REQUEST FOR INFORMATION DATE: August 31, 2016 NO.: RFI-262

Project Name: 15051-Webster University Interdisciplinary Science Building Project No.: 15051

Subject: Silicone Boot and EPDM Attachment at Curtainwall parapet

1 HEAD DETAIL

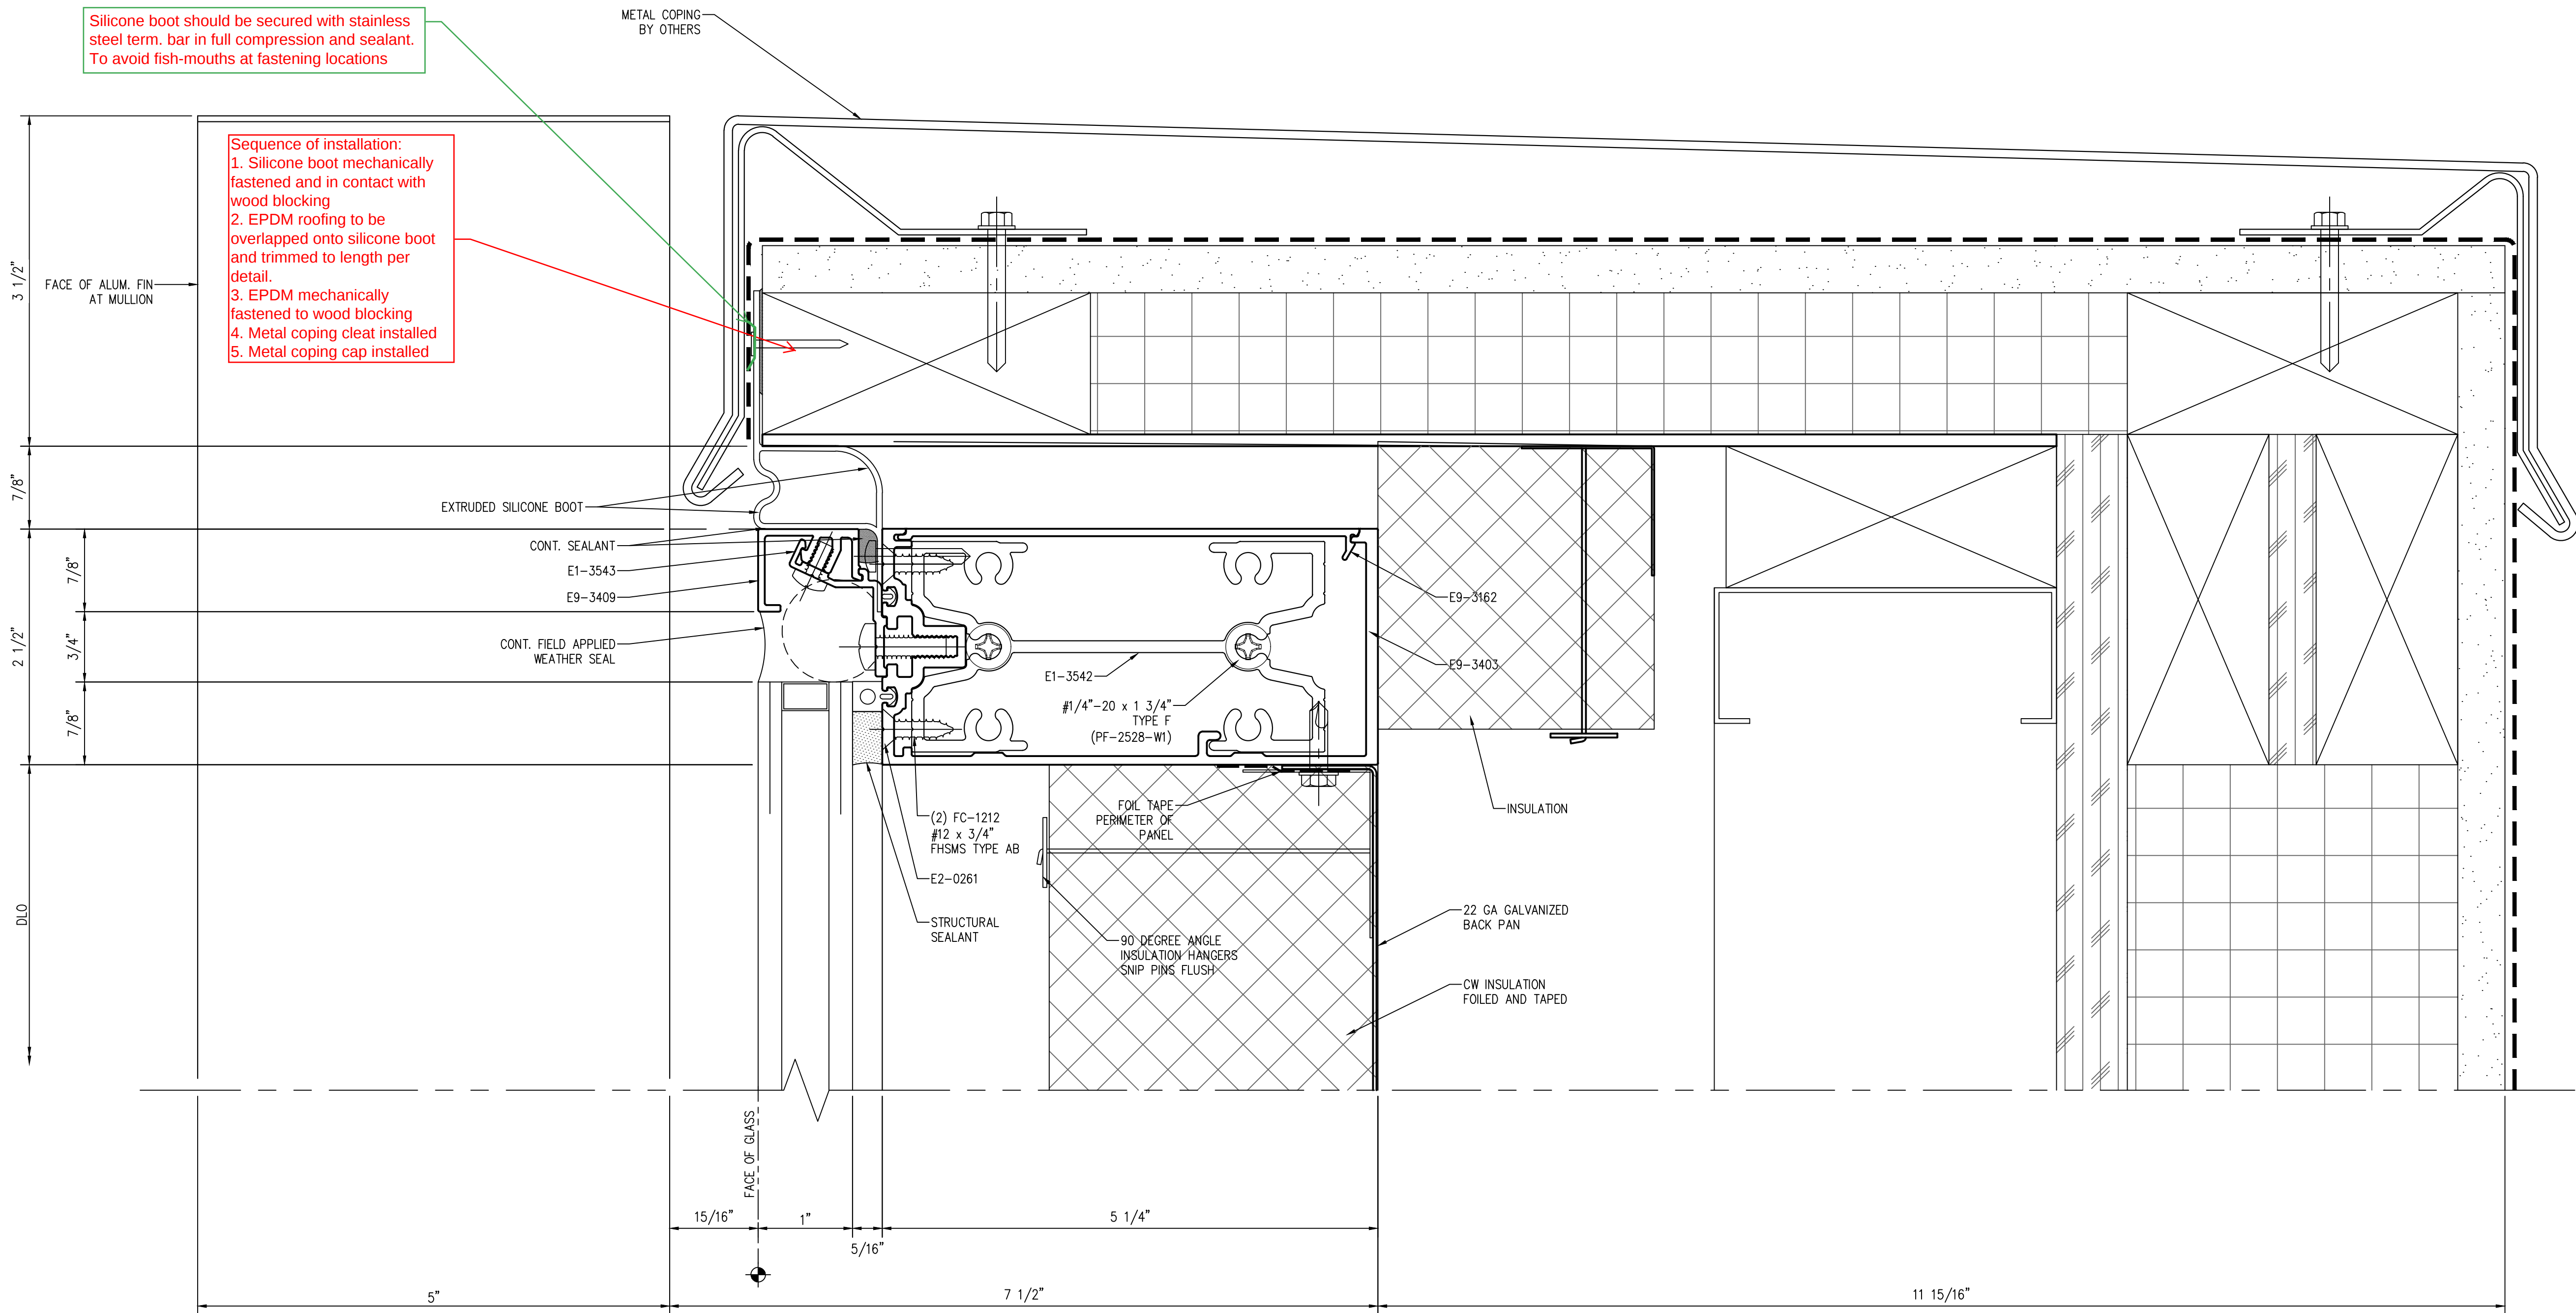
Please confirm the attachment detail / transition of the silicone boot and EPDM is acceptable. Reference compatibility letter from Johns Manville and requested attachment method. The purpose of this RFI is to gain agreement on the proposed attachment method so it can be installed on the mockup

I have reviewed head detail 1 on sheet SK-04 for this project. The detail shows a silicone boot in contact with JM EPDM membrane at the outside edge under the coping. JM does not have compatibility testing with the specific boot and our membrane, however silicone in general does not adversely affect the EPDM membrane and we do not anticipate any issues where these products come in contact. This application will not affect the terms and conditions of our guarantee we intend to issue on this project.

The detail also shows the EPDM membrane being fastened with the coping cleat. JM does require the membrane to be independently fastened to the wood nailer on the outside face.

see comments below.
